Instrument Cluster Reprogramming (MID
140)
GU, GR

PI0889 Differential Lock Engagement Status Alarm Update (MID 140)

(December 2021)

Granite (GR)

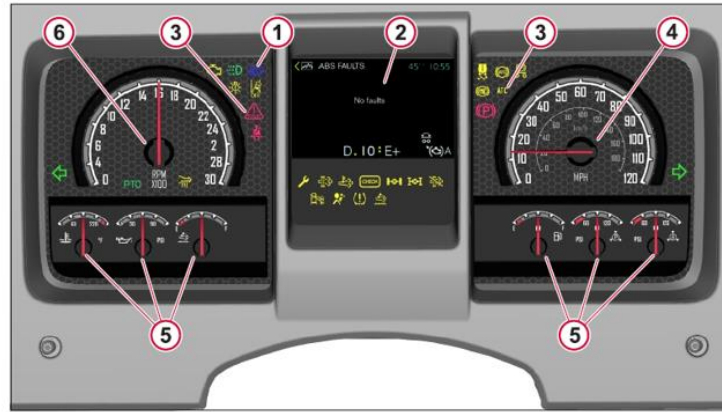
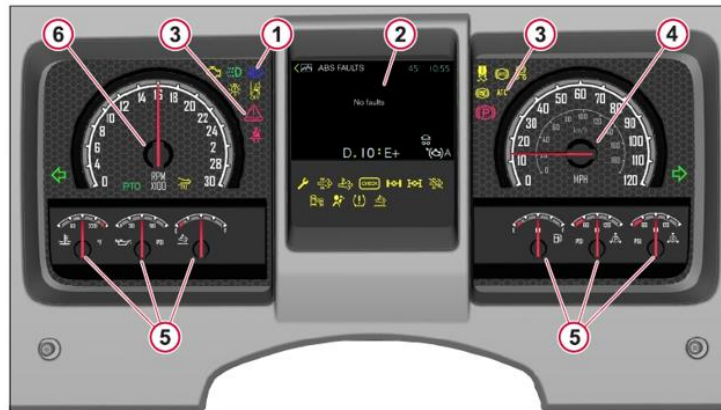
This notification is to announce that Mack trucks has released improved differential lock warning software for the instrument cluster. Previously the driver would be initially alerted to the system engagement with a popup in the cluster along with an audible alarm that lasted approximately five seconds then would automatically dismiss. The improved software keeps the message and alarm persistent until the system is disengaged. The message in the cluster can be ignored for thirty seconds but will return. The following highlights the differences between the current and new software. To perform the update, follow the procedure below

Current Software

Diff-Lock Engaged: (Popup + audible + Icon) Begins

Popup = 30sec

Audible = 5sec

Icon = Continuous

New software

Diff-Lock Engaged: (Popup + audible + Icon) begins

**Popup = Continuous, but can be dismissed.
If dismissed will return > 30sec**

Audible = follows popup

Icon = continuous
